# LAKEWOOD LOCAL SCHOOLS

## Modular Building Request for Proposals (RfP) Q&A

Fire-Light MS -9200 Control Panel. Picture is below.

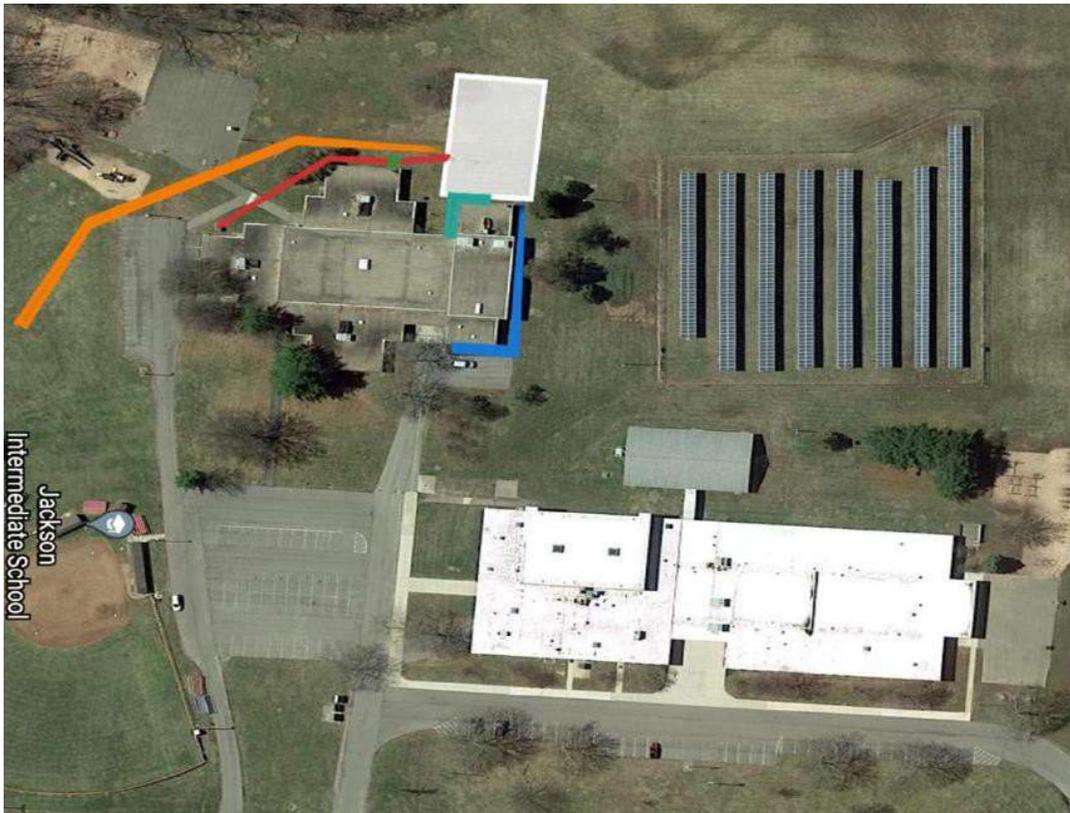
5. **Please provide the make and model for Jackson's current Fire Alarm system. This information will be necessary in order to quote a compatible system in the modular classroom building.**

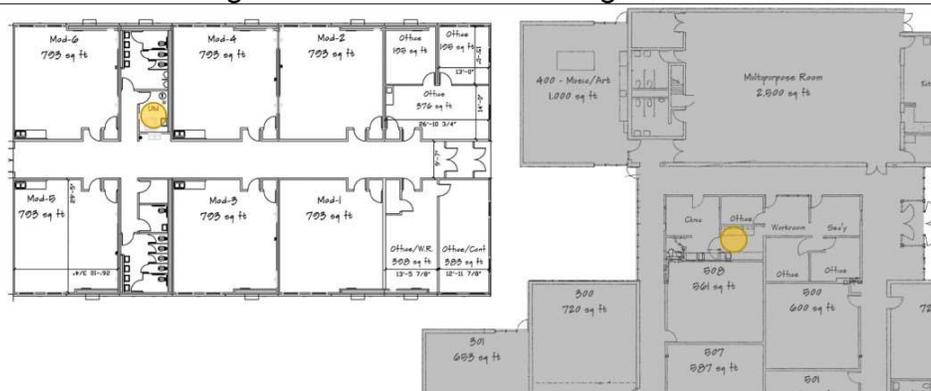
13. The site plan included in Section 1.4 has several lines drawn in various colors (blue, teal, red and orange). However, it is not clear what information these colors and their pathways are meant to convey. Please provide clarification on the site plan colors and pathways.

16. There is no information on the proposed gas service connection point from Jackson. Please indicate the proposed or assumed connection points for the gas service from Jackson, the proposed path of the new gas service inside Jackson (if applicable) and provide any available information on the existing gas service to be tied into so that the bidder may responsibly price this work.

Clarification is provided in the accompanying document:

- Orange line is sewer
  - Red line is electrical
  - Green line is pad mounted transformer
  - Teal line is connecting corridor between the modular building and the main building
  - Blue line is water
14. **Who will be responsible for determining the adequacy of existing utilities to accommodate the proposed Modular Classroom Building?**  
The vendor will be responsible for determining the adequacy of existing utilities to accommodate the proposed Modular Classroom Building.
15. **There is no information on the proposed water and sewer utility connection points. Please indicate the proposed or assumed connection points for these services and provide any available information on the existing utilities to be tied into so that the bidder may responsibly price this work.**  
See the answer, picture and legend with question #13.
